COBRA Guidance Note

Leakage at the joint between the Y-piece and the interface block

Figure 1 - Joint between the Y-piece and interface block with o-ring seal

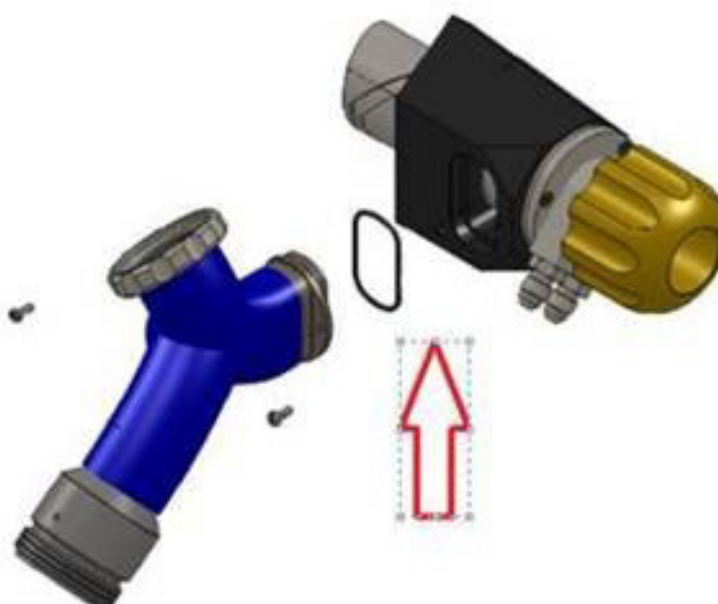
The joint between the Y-piece and the interface block on the COBRA helmet uses an o-ring seal. Additionally, the joint is coated with silicone RTV as a back-up measure. Although this joint has performed satisfactorily, there have been occasional reports of gas leakage in this area, especially if the helmet receives a knock or impact. The potential for leakage is increased because the spigot and bore are not circular, therefore any twisting at the joint tends to pull the o-ring away from part of the bore causing leakage.

Any time this leakage has been observed, it has been minor and the positive pressure in the COBRA set has prevented water ingress.

A replacement o-ring has been identified, that has a larger cross section but a smaller internal diameter. This increased volume of sealing material fills the joint more fully, preventing any leak even if the Y-piece is substantially manipulated. It is not necessary or recommended to use silicone RTV in conjunction with this new seal.

To fit the new seal, disconnect the helmet hose from the Y-piece and remove the clamp holding the Y-piece to the helmet. Remove the two screws fixing the Y-piece to the interface block. Withdraw the Y-piece, discard the o-ring and clean all silicone from the bore and the spigot.

Stretch the new o-ring over the spigot, lubricate and refit the Y-piece to the interface block, pulling the items together using the fixing screws. Refit the other parts, remembering to seal the clamp screws with silicon RTV where they pass through the helmet shell.

Replacement o-ring part number RN0813-7. These will be made available to users on request.
